**Comment Response Matrix  
for  
NRC Staff Request for  
Additional Information on the  
Draft Basis for Section 3116 Determination and  
Associated Performance Assessment for the  
H-Area Tank Farm at the Savannah River Site**

**October 2013**

Prepared by: Savannah River Remediation LLC  
Closure & Waste Disposal Authority  
Aiken, SC 29808

**Figure RAI-NF-12.1: MOP Radionuclide Dose Contributions Using Base Case Modeling Assumptions (Annular Inventories)**

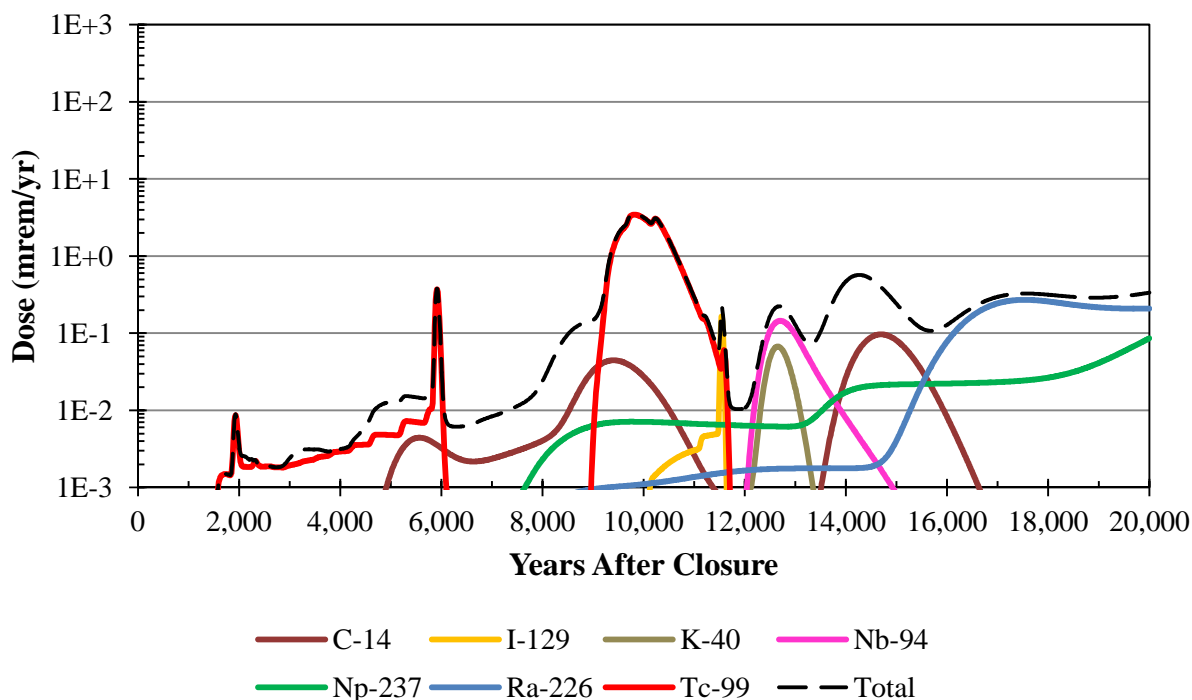
In DOE's PORFLOW<sup>®</sup> model (see Figure 1), the annular waste in Tanks 9H and 10H is loaded within the bottom of the annular reducing grout. Loading of the annular waste into the bottom of the reducing grout in DOE's PORFLOW<sup>®</sup> model assigns  $K_d$  values associated with reducing grout. For redox-sensitive radionuclides, this appears to significantly limit mobility even though this waste is assumed to be highly mobile. In addition, the preferential pathway represented in cases B-E does not intersect the annular waste in Tanks 9H and 10H. Based on operational experience, NRC staff is concerned that groundwater in-leakage into the annular region could occur and that the associated risk with this scenario is not adequately addressed within the Performance Assessment.

For further insight, and to address more quantitatively this RAI the GoldSim model was used in deterministic mode to develop a set of additional figures showing the radionuclide-specific dose contributions from the assumed annular inventories. These figures show the peak radionuclide doses, regardless of sector. Figure RAI-NF-12.1 shows the radionuclide contributions to the MOP dose from only the annular inventories, using Base Case (Case A) modeling assumptions.

The peak dose in Figure RAI-NF-12.1, near 9,800 years after final facility closure, occurs due to the oxidation of the annular grout for the Type I tanks with intact liners (Tanks 9, 10, and 11). Note that in the GoldSim model, this transition occurs around 8,700 years. Prior to this transition, less than 1 % of the Tc-99 within the annulus inventories of Tanks 9, 10, and 11 is released. The combined annulus inventory doses from these three waste tanks peaks at approximately 3.5 mrem/yr.
